Informal document **GRSG-116-33**
(based on **ECE/TRANS/WP.29/GRVA/2018/11**)
(116th GRSG, 1-5 April 2019
agenda item 8)

UN Regulation No. 55: Examples of mechanical coupling devices of class A

Coupling ball
Class A

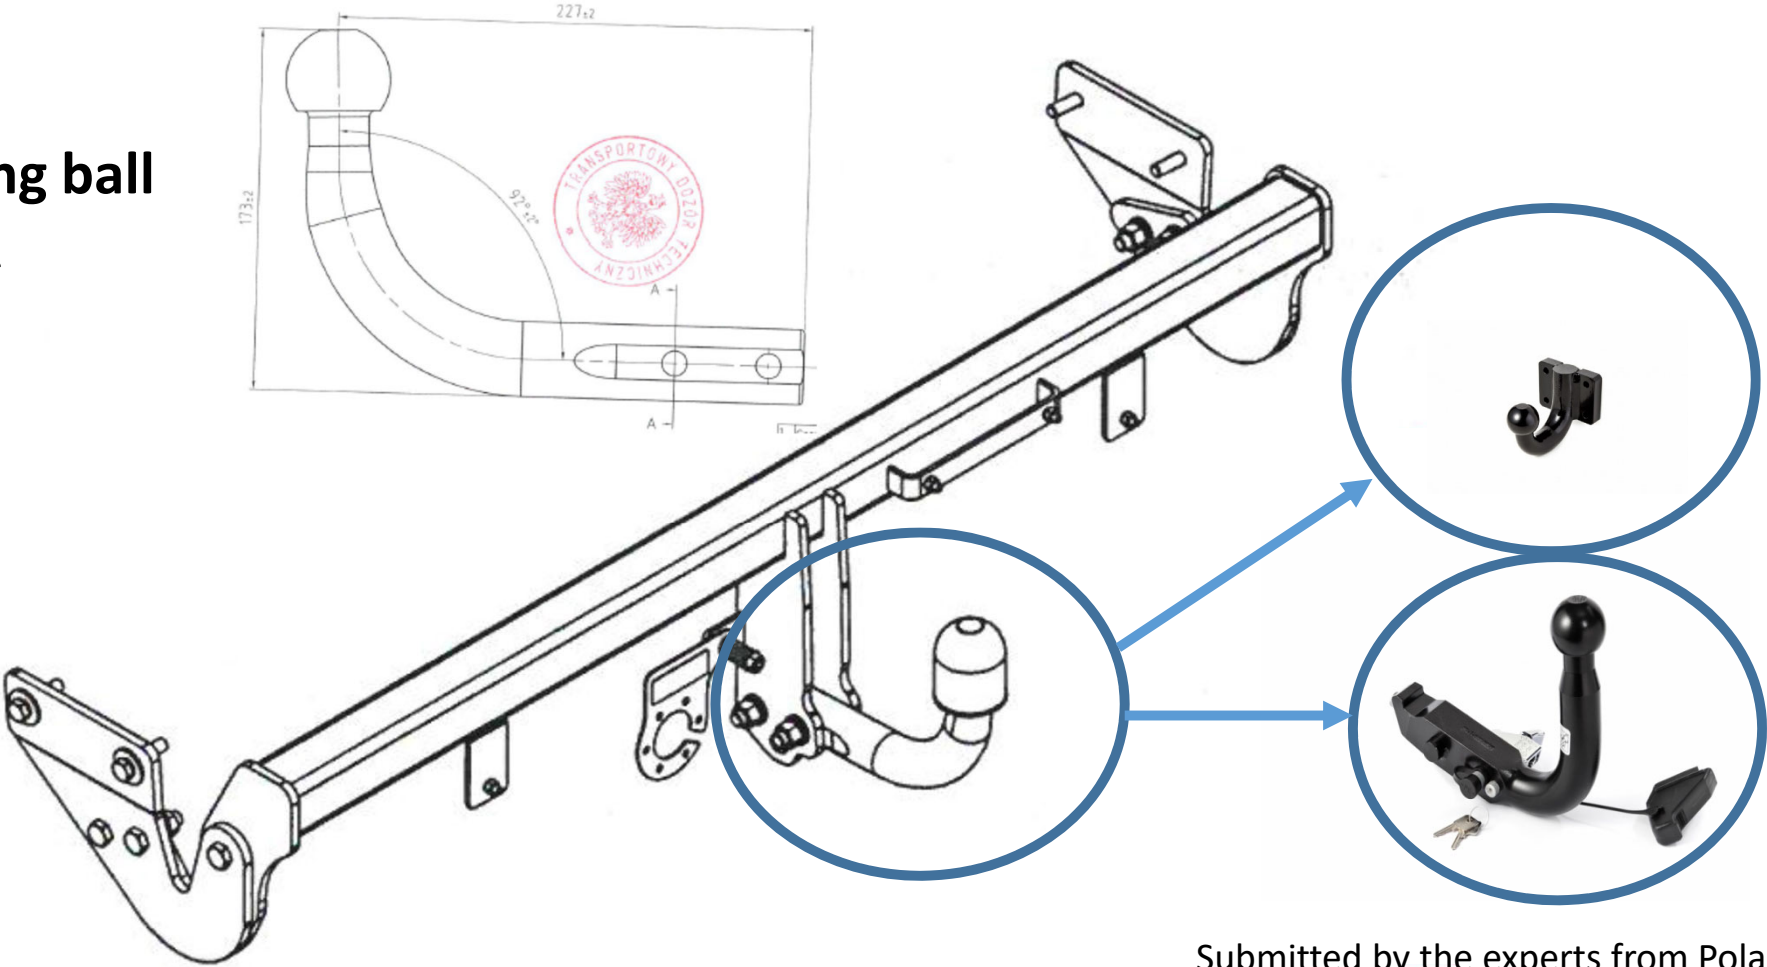
1. The Regulation requires to fill in item 9.3. if mechanical coupling devices and components class A are going to be approved. In the case of a coupling ball approval as a component only, this component is not dedicated for a specific vehicle. The requirement to fill in item 9.3. in case of component seems confusing as approved coupling ball shall be treated universally and can be used in different vehicles.

2. This proposal suggests filling in item 9.3. only in case of approval of completed mechanical coupling device. Therefore, it is proposed to amend the sentence and add ", if applicable".

"9.3. For class A mechanical coupling device or components, including towing brackets, **if applicable**:
